SUPPLEMENTAL BID BULLETIN NO. 1

**SUPPLY, DELIVERY, INSTALLATION AND TESTING OF VARIOUS MULTI STAGE RICE MILLS  
 (PHilMech-RCEF-23-11-40-Rebidding)**

## Annex A

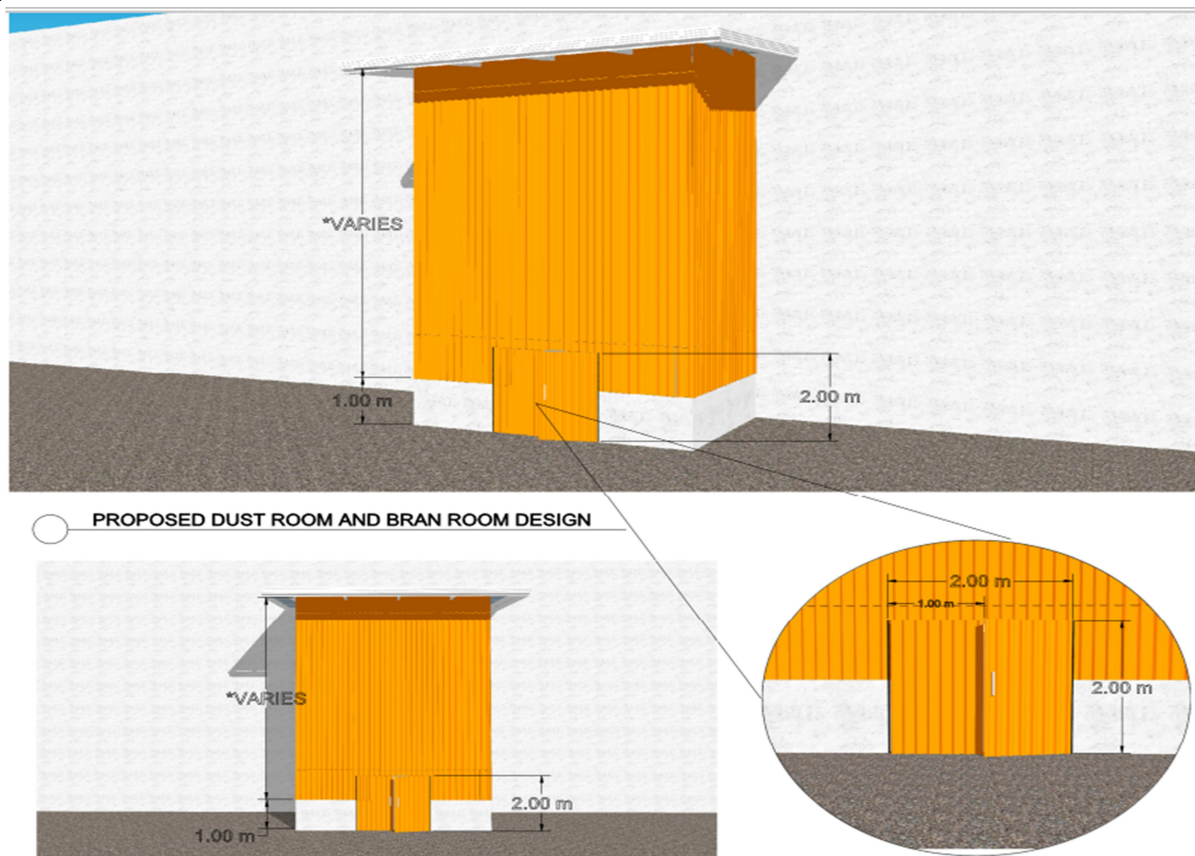
4. Issue / Proposal: Suggestion that the rice bran room could be manufacturer or supplier's standard.		
Action Taken/Reply: <b>The technical specification is retained. Please see the attached layout in Annex A for the Bran room.</b>
